MONTGOMERY COUNTY HISTORIC PRESERVATION COMMISSION
STAFF REPORT

Address:	5904 Cedar Parkway, Chevy Chase	Meeting Date:	10/24/2018
Resource:	Outstanding Resource Chevy Chase Village Historic District	Report Date:	10/17/2018
Applicant:	David O'Neil & Laura Billings (David Jones, Architect)	Public Notice:	10/10/2018
Review:	HAWP	Tax Credit:	Partial
Case Number:	35/13-18Z	Staff:	Dan Bruechert
Proposal:	Garage demolition, non-historic addition removal, new construction, hardscape, and landscape alterations.

STAFF RECOMMENDATION

Figure 1: Stone tower with arbor/pergola.

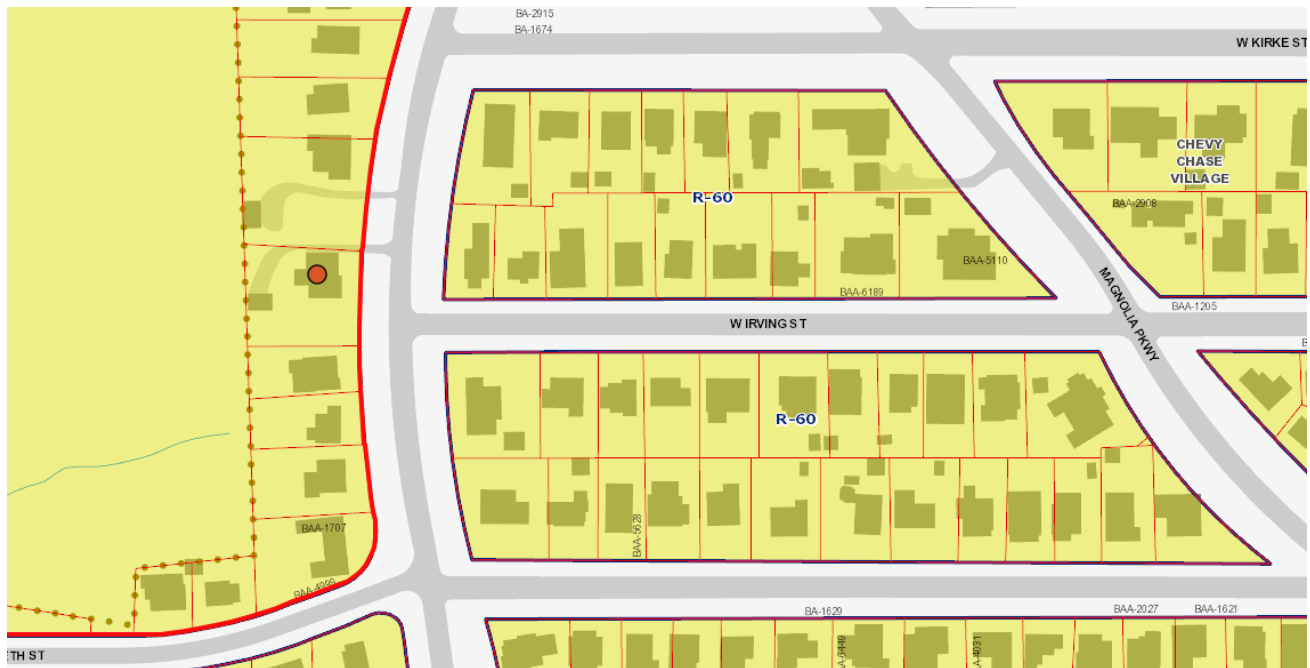
In the south end of the property there is a folly/gazebo that is connected to the house by a pergola. These elements are constructed from masonry that matches the construction of the house foundation. The pergola is largely overgrown with vines and ivy, with the remnants of deteriorated wood fencing between the columns (see the image below). The applicant proposes to add a second row of columns to the pergola, behind the existing historic columns and construct a new pergola structure. Aligned with these new columns the applicant proposes to install a 5’ (five foot) iron fence enclosure with a gate (discussed below). Based on the input from the HPC at the two preliminary consultations, Staff finds the proposal to add a new row of stone columns is appropriate. The applicant proposes to match the column design and materials. Staff finds that alterations to this feature is most analogous to gazebos, which should be subject to moderate scrutiny. Staff further finds that expanding this feature in a matting design is an appropriate treatment within the Chevy Chase Village Historic District, per the *Guidelines*.

3. A sample board of the stone and mortar for the new pergola columns needs to be created for review and approval with final approval authority delegated to Staff; and with the general condition applicable to all Historic Area Work Permits that **the applicant will present 3 permit sets of drawings to HPC staff for review and stamping prior to submission for permits (if applicable)**. After issuance of the Montgomery County Department of Permitting Services (DPS) permit, the applicant will arrange for a field inspection by calling the DPS Field Services Office at 240-777-6370 prior to commencement of work and not more than two weeks following completion of work.
